Access Compliance Report Public Rights-of-Way (Curb Ramps)

Main Street: UNIVERSITY_AVE Cross Street: ETON_PL Location: SW

ADA ID: RPRK211026144741 Ramp Type: Type 4 - Parallel Initial Pass/Fail: Pass Overall Compliance: No Severity Score: 25

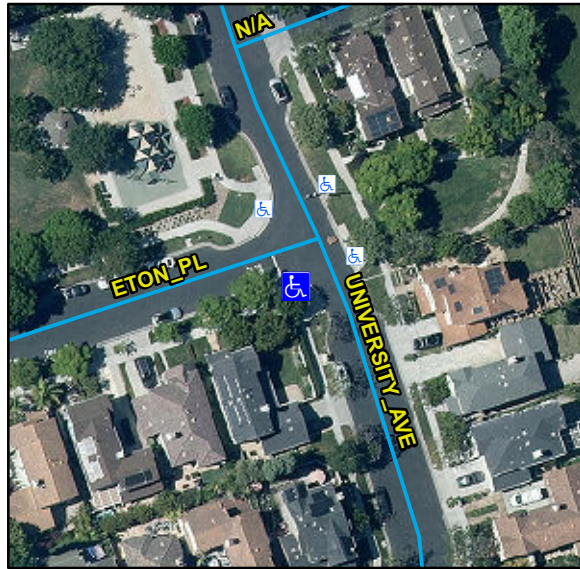
Compliance	Description	Data	Compliance	Description	Data
N/A	Ramp Length LT (in)	130	N/A	Ramp Length RT (in)	127
Yes	Ramp Width LT (in)	90	Yes	Ramp Width RT (in)	90
Yes	Ramp Run Slope LT (%)	6.8	Yes	Ramp Run Slope RT (%)	3.1
Yes	Ramp Cross Slope LT (%)	1.9	Yes	Ramp Cross Slope RT (%)	1.3
N/A	Landing Present	No	No	DWS Provided	No
N/A	Landing Length (in)	N/A	N/A	DWS Contrast	N/A
No	Landing Width (in)	N/A	N/A	DWS Length (in)	N/A
No	Landing Run Slope (%)	N/A	N/A	DWS Full Width	N/A
No	Landing Cross Slope (%)	N/A		DWS Offset Type	N/A
N/A	Landing Movement Obstructed?	No	N/A	DWS Offset Left (in)	N/A
	Landing Movement Type	Curb	N/A	DWS Offset Right (in)	N/A
N/A	Landing Shared	N/A			
N/A	Clear Space	Yes			
N/A	Clear Space To Crosswalk (in)	48			
N/A	Marked Crosswalk 1	No	N/A	Marked Crosswalk 2	No
	Crossing 1 Direction	E		Crossing 2 Direction	N
	Marked Crosswalk 1 Width (in)	N/A		Marked Crosswalk 2 Width (in)	N/A
N/A	Ramp Inside Crosswalk 1	N/A	N/A	Ramp Inside Crosswalk 2	N/A

Crossing 1 Slope (%)	4		Crossing 2 Slope (%)	1.3
	Crossing 1 Cross Slope (%)	1.7		Crossing 2 Cross Slope (%)	3.2
Yes	Gutter Ponding	No	No	Curb Slope	15.4
Yes	Gutter Lip Height (in)	0		Road Run Slope (%)	1.5
No	Gutter Run Slope (%)	8.7		Road Cross Slope (%)	2.9
No	Gutter Cross Slope (%)	3.4	No	Perpendicular Joint Present	No
Yes	Overall Surface Condition	Acceptable			
	Cross Gutter Present?	No		Spandrel Present?	No
	Replace Cross Gutter?	N/A		Replace Spandrel?	N/A

Remove & Replace Curb Ramp With Two New Directional Ramps or Equivalent. Remove & Replace Gutter.
